**CERTIFICATE OF APPROPRIATENESS**

**Property:** 1501 Ashland St, East 88' of Lot 18, Tract 18B, Block 146, Houston Heights Subdivision. The property includes a historic 800 square foot, one-story wood frame single-family residence situated on an approximately 2,900 square foot lot (≈ 88' x 33') corner lot.

**Proposal:** Alteration – Addition

**SOUTH (FRONT) FACING W 15<sup>TH</sup>**  
PROPOSED

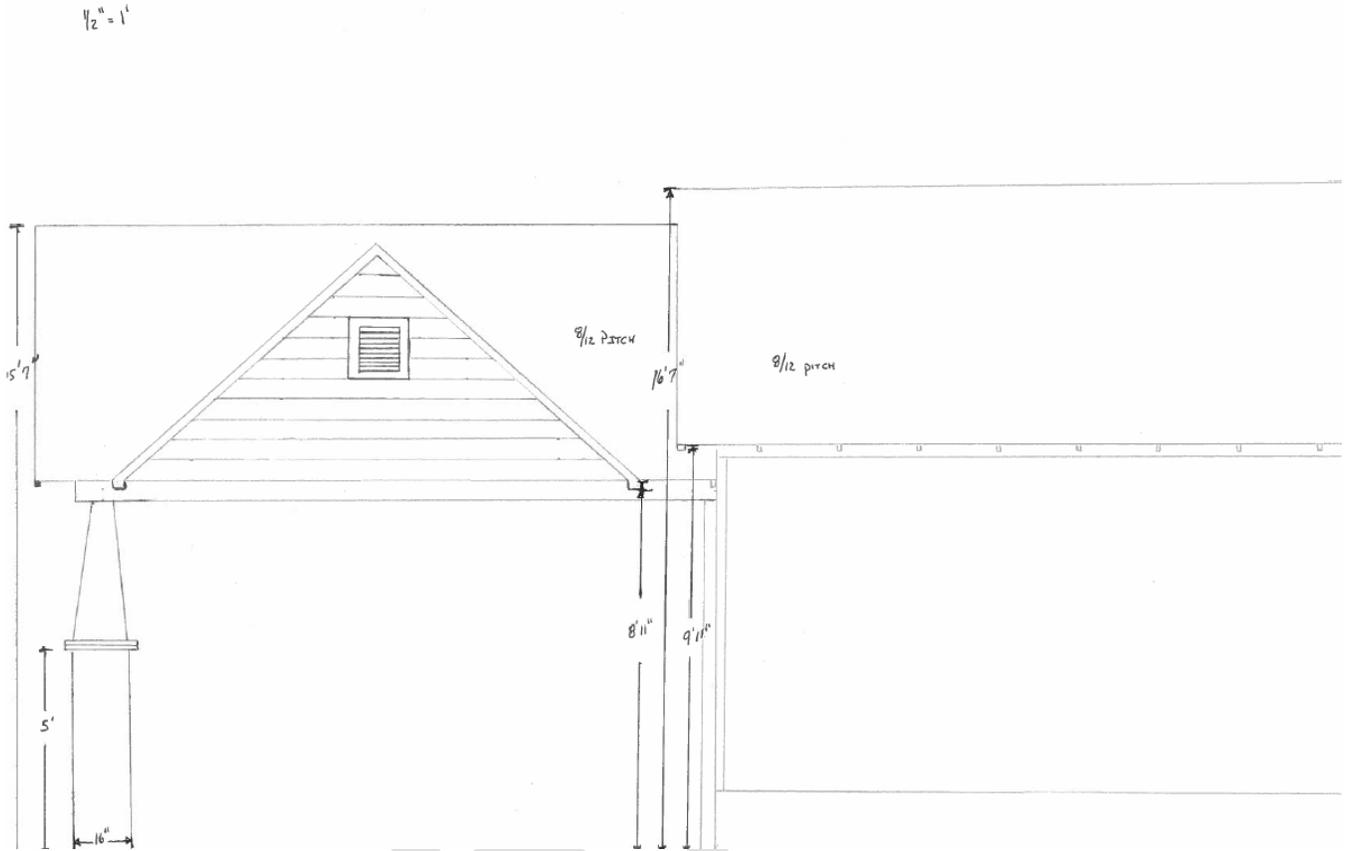
- (1) The proposed activity must retain and preserve the historical character of the property;  
*The front-facing gable on the carport draws attention away from the historic residence. The gable extends 2' beyond the 16" eave overhang and is very prominent. Carports are accessory structures and should be subordinate to the existing residence. Accenting an accessory structure with a prominent gable visible from the street is not appropriate.*

- (10) The proposed alteration or addition must be compatible with the massing, size, scale material and character of the property and the context area; and  
*The front-facing cross gable on the carport is not compatible with the character of the property or the context area. Carports are accessory structures and should be subordinate to the existing residence. Accenting an accessory structure with a prominent gable visible from the street is not appropriate.*

**Roof:** The proposed carport has a gable roof with an 8:12 pitch to match the roof style and pitch of the existing residence. The roof will be covered with composition shingles to match the shingles on the existing residence. The carport also has a prominent front-facing gable that extends 2' beyond the 16" eave overhang.

**Front Elevation:** The proposed carport will attach to the rear elevation and elongates the south elevation by 17'.  
**(South)** The carport is support by two brick/wood columns with a 1'-4" wide by 5' tall brick base intended to correlate with the column on the residence's front elevation. The carport also has a prominent front-facing gable with a vent.

**Recommendation:** Approval with conditions: Approval for attached carport with the condition that the front-facing gable be removed.

*Staff feels the project would meet Criterion 1 if the applicant were to eliminate the gable.*
- (2) The proposed activity must contribute to the continued availability of the property for a contemporary use;

*Staff feels that the project would meet Criterion 10 if the applicant were to eliminate the gable.*
